ADDENDUM# 3

**University of Kentucky
2555.0 Delta Gamma House New Construction**

Addendum #03

Written Questions and Answers

A9 SECOND FLOOR RR - ENLARGED PLAN

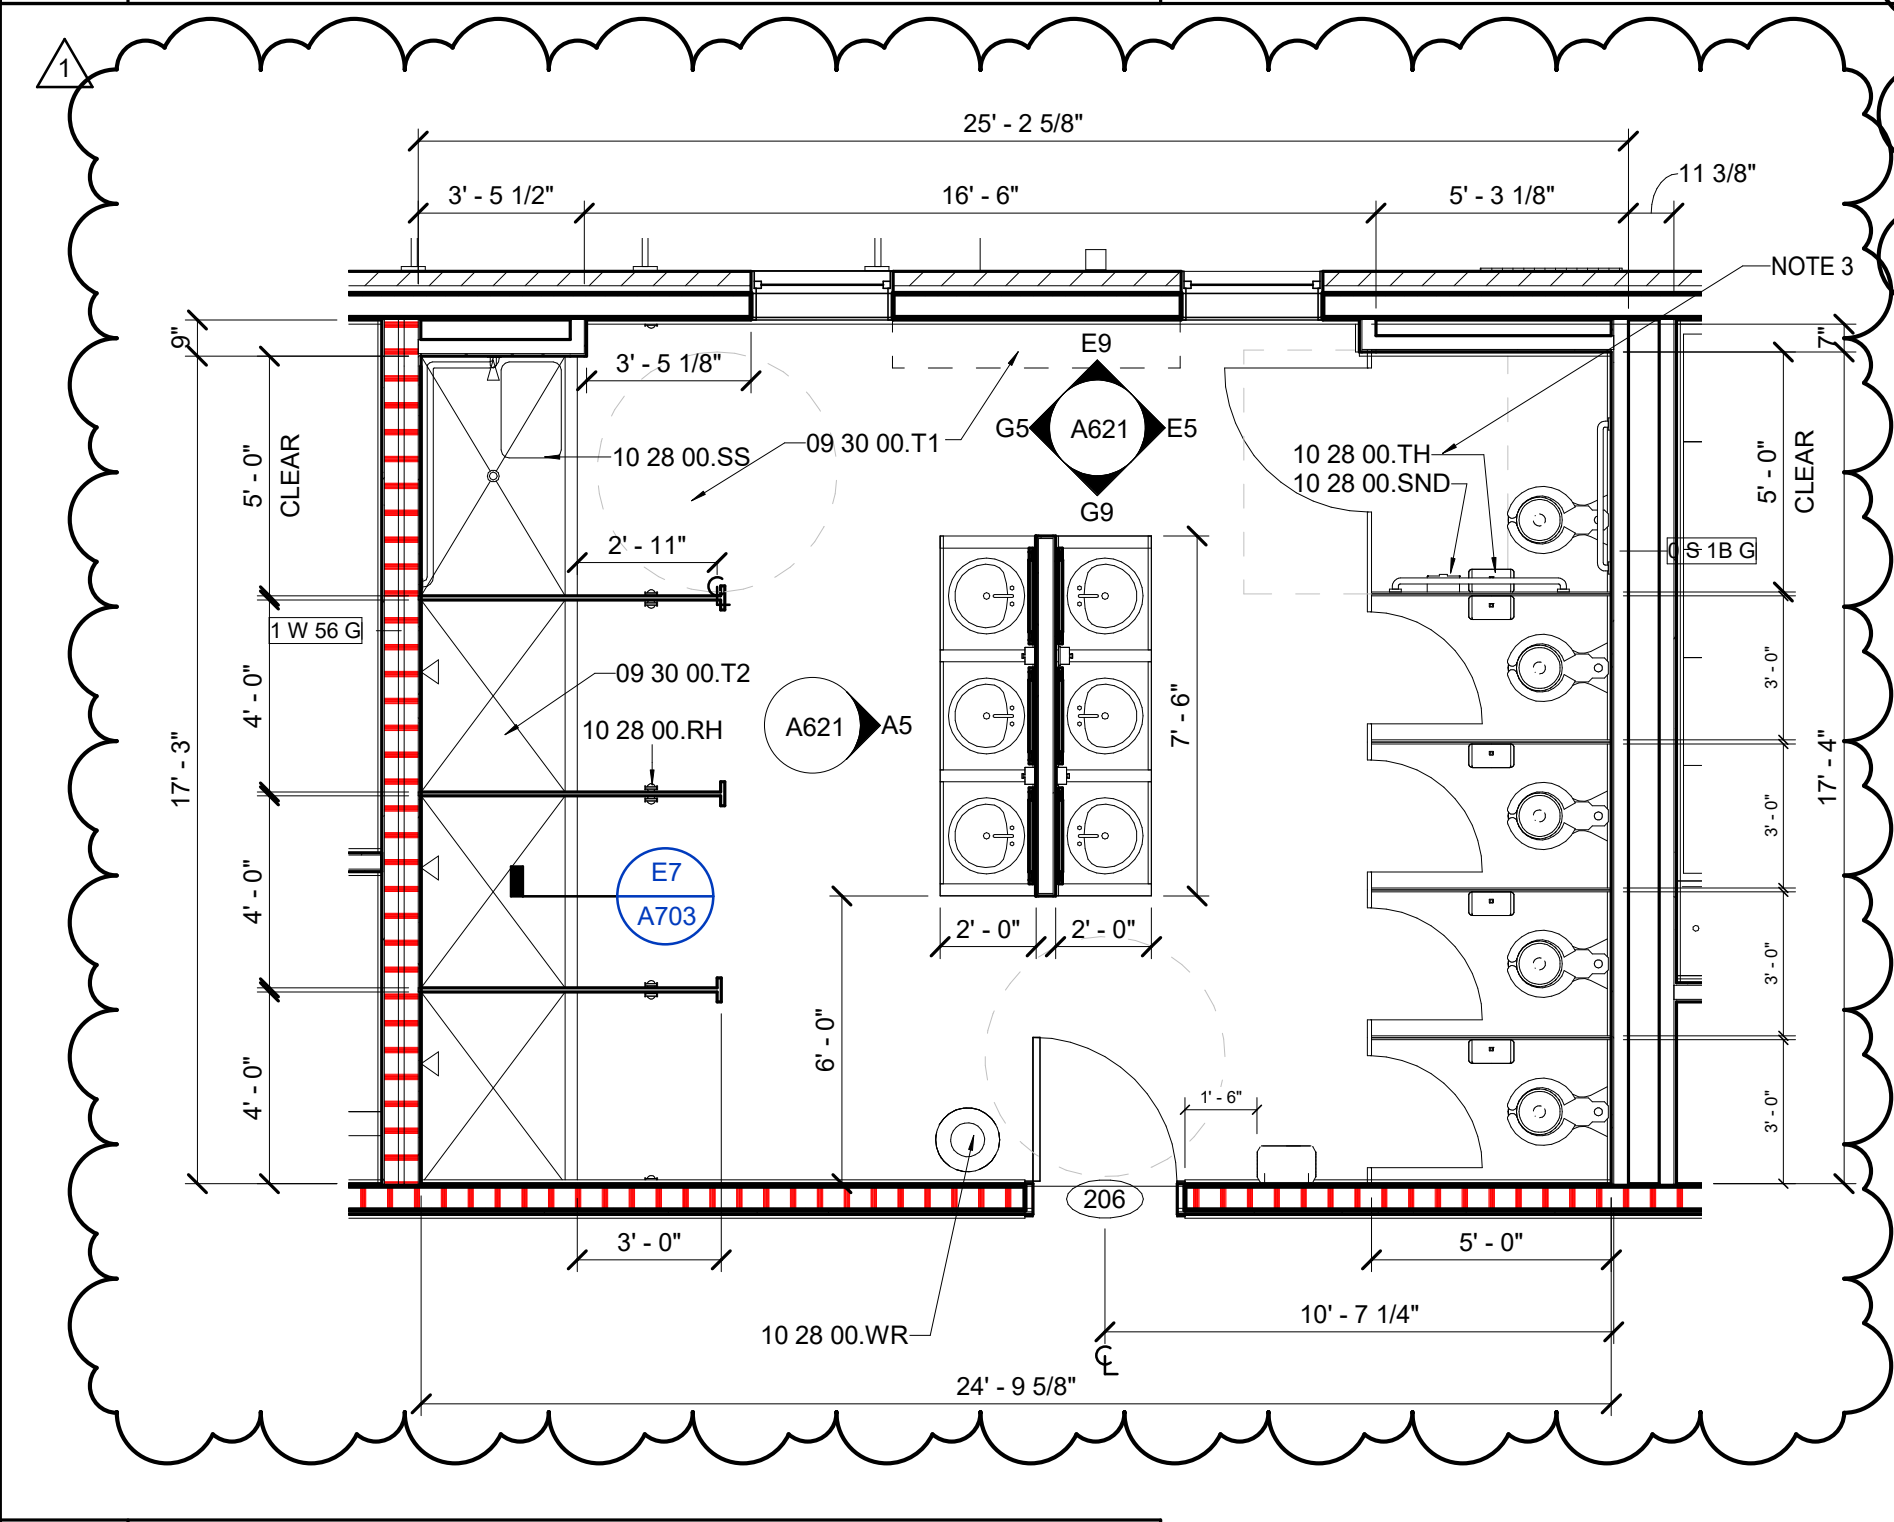
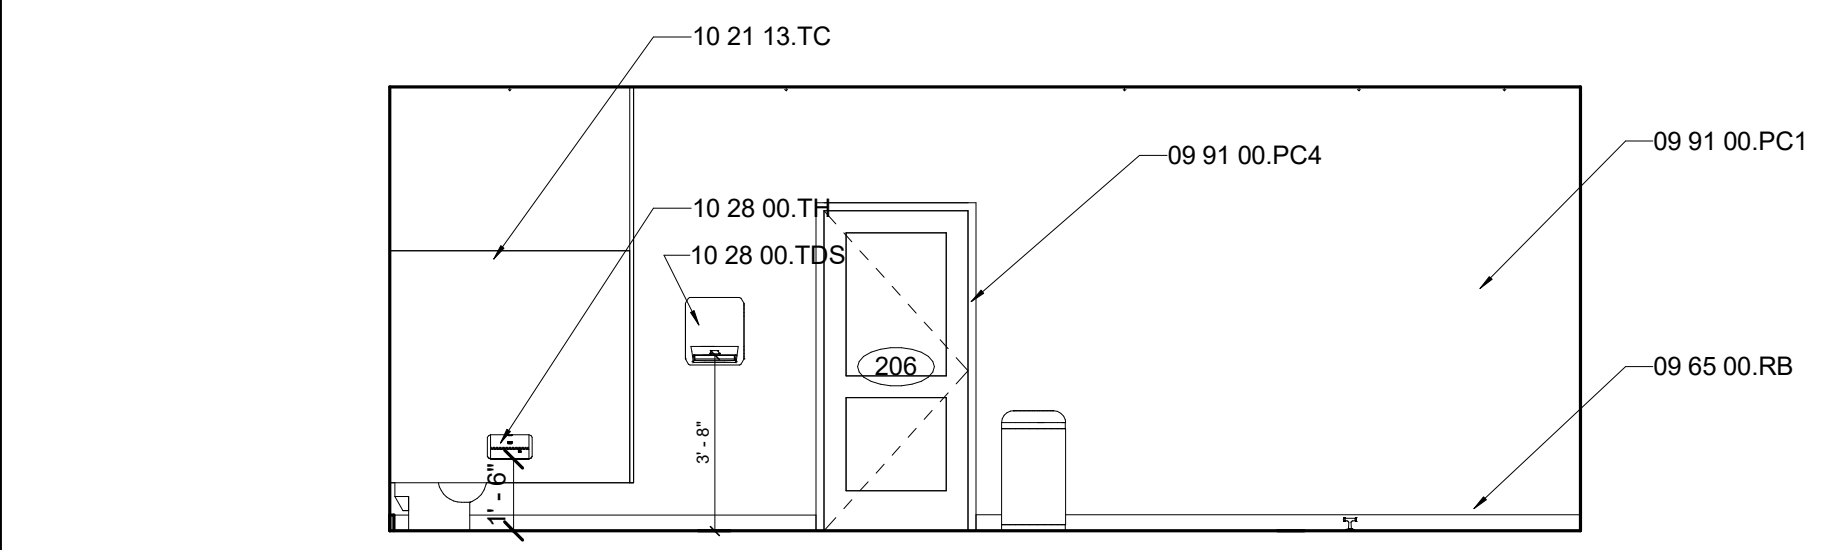
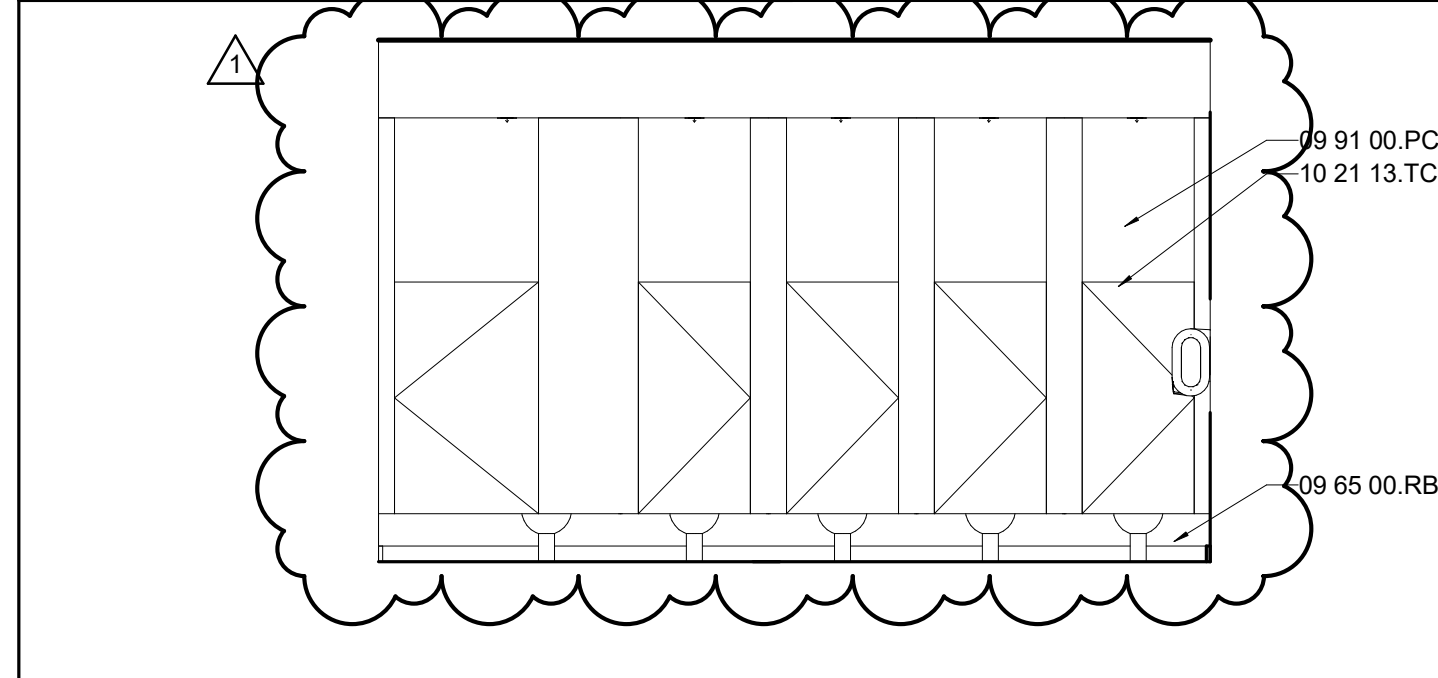
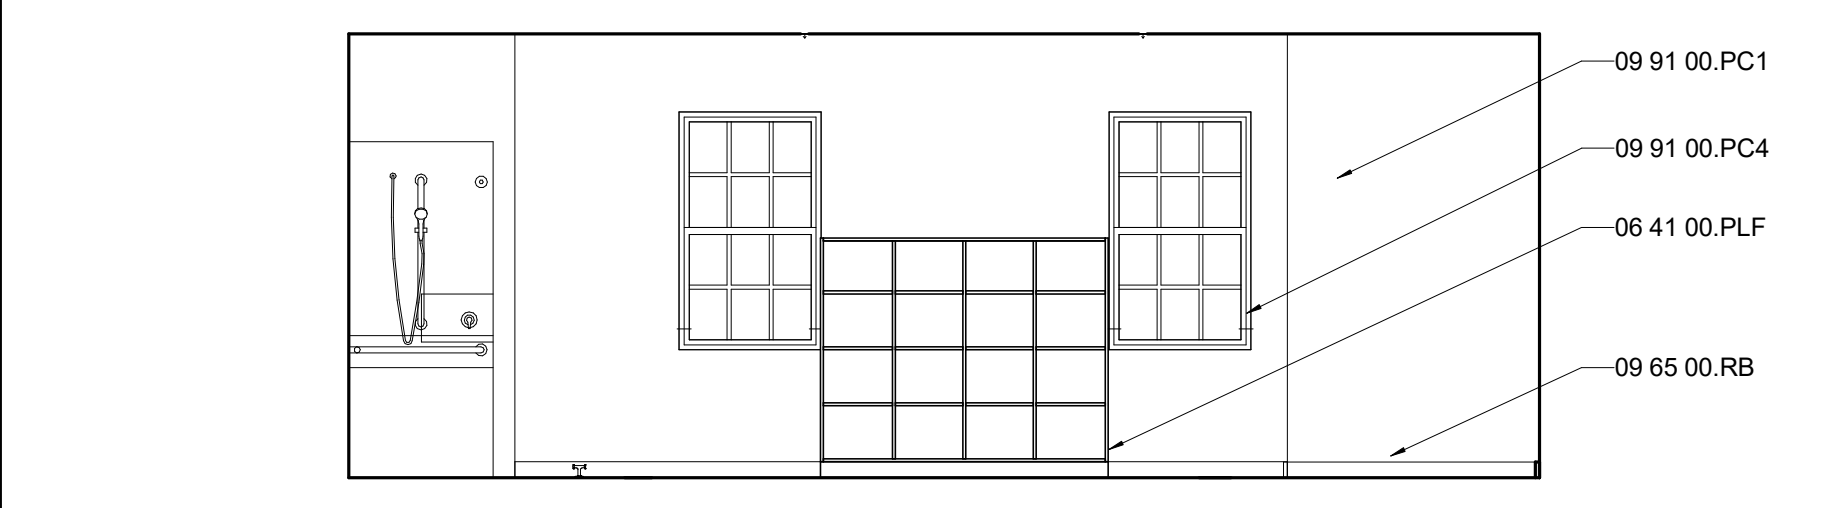
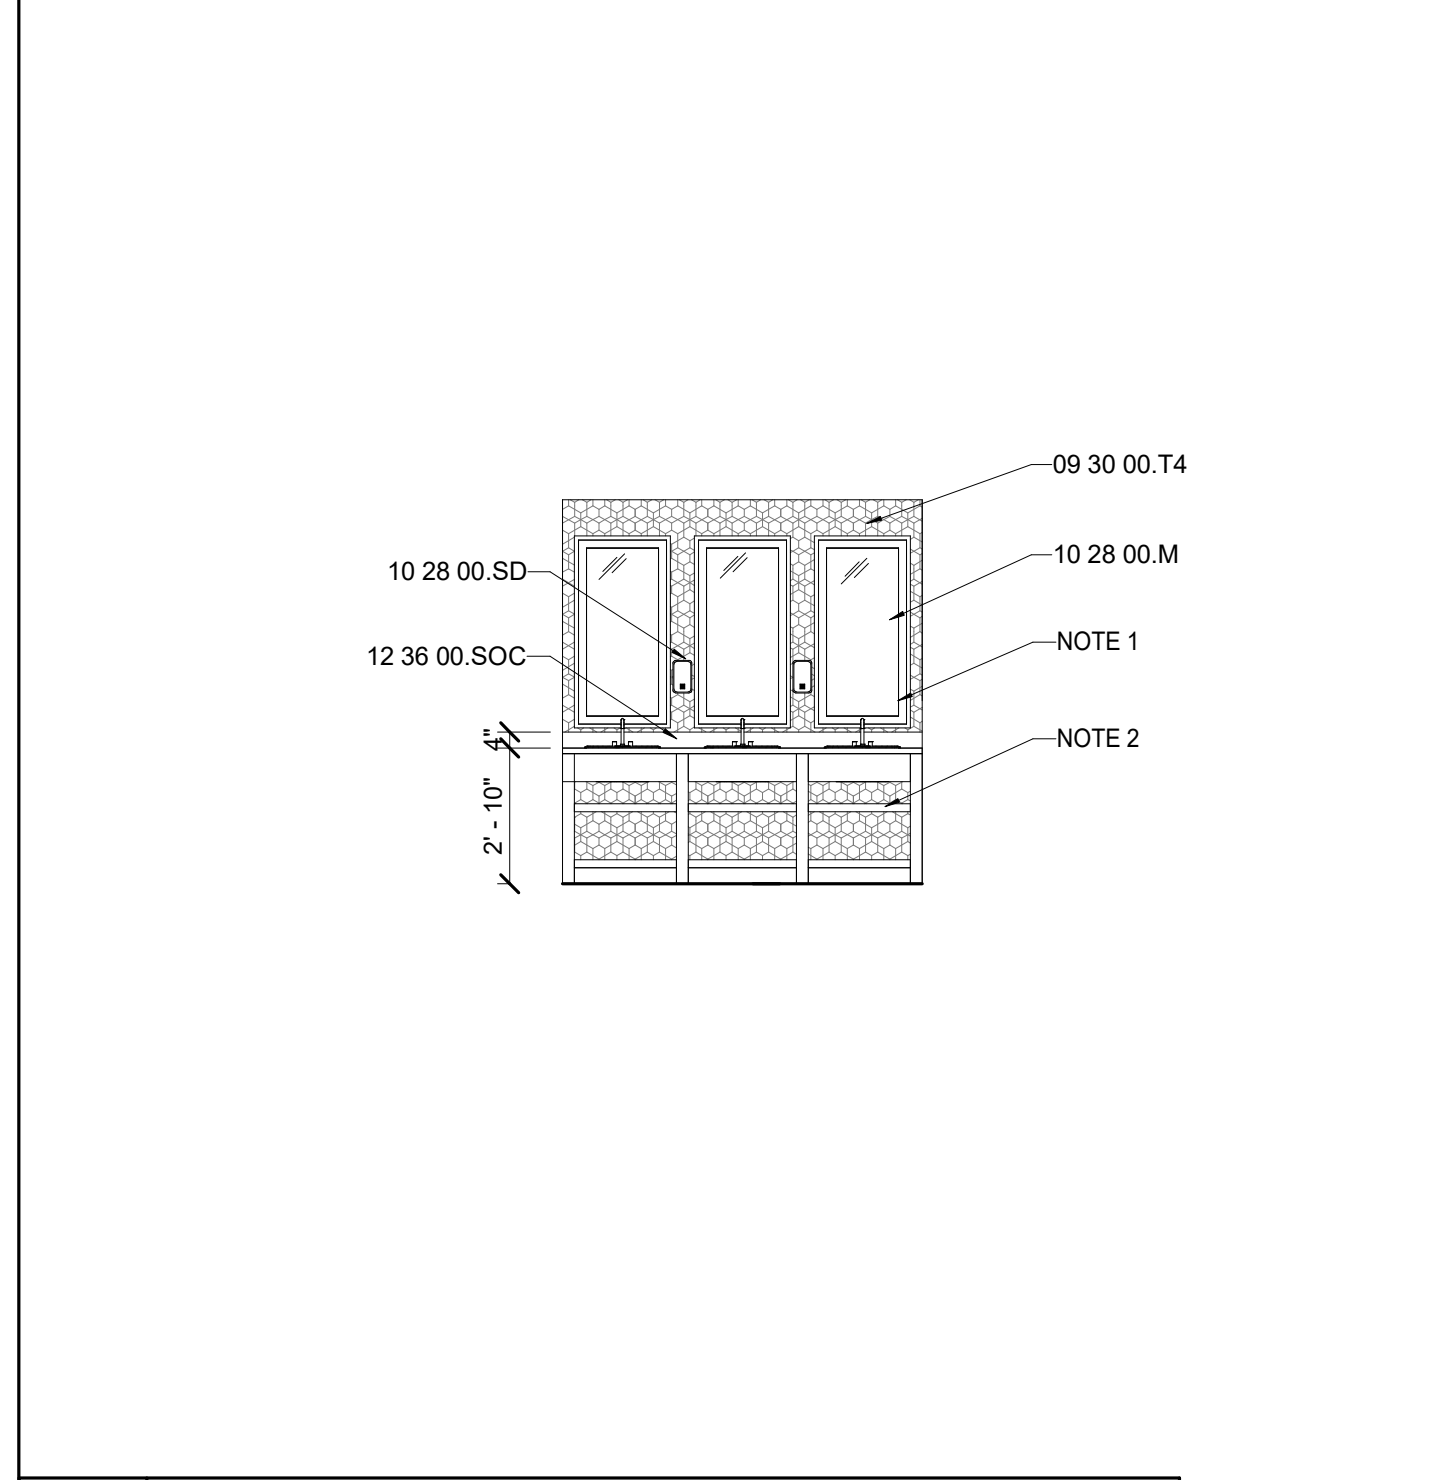
25.	<p>Question about the RR drawings please. Room 206 & 306 have T2 listed as a floor tile on the Interior Finish Plan(A701). The finish schedule(A700) T2 is listed as a wall tile and in the interior drawings (A621 & A622) shows the tile being installed in what appears to be an ADA Pre-Fab Bathtub. In the RR elevation drawings(A621 & A622) they show what appears to be two different wall tiles (E9 & G5) with only T5 designated. We assume the second undesigantated tile is T2, as that is the ADA shower and tub. My question is: do they want T2 installed in the ADA tub and shower as both wall and floor tile, wall tile only or am I totally out to lunch on this? Could you please advise?</p>	LAS	<p>Bathroom elevations have been revised to reflect intended design. There are no pre-fab showers in the main restrooms.</p> <p>The wall tile is T5 as shown on revised elevations. T2 is floor tile only.</p> <p>For clarification, T3 has been removed from the project.</p> <p>Please refer to revised sheets A621 and A622, attached.</p>

39.	For Spec Section 102113 – Toilet Compartments – Elevations in the plans show compartments that look to be overhead braced/floor mounted, however specs state ceiling hung. Please Advise.	LAS	Toilet compartments will be ceiling-hung as specified. Drawings have been revised to reflect this. Refer to revised Sheets A621 and A622, attached.

- 1. PROVIDE BLOCKING FOR WALL HUNG MIRRORS
- 2. OPEN SHELVING UNDERNEATH
- 3. SEE A622 FOR TYPICAL ADA STALL
- 4. 1" SHOWER PARTITION WALL. SEE A9 ENLARGED PLAN FOR ASSEMBLY.
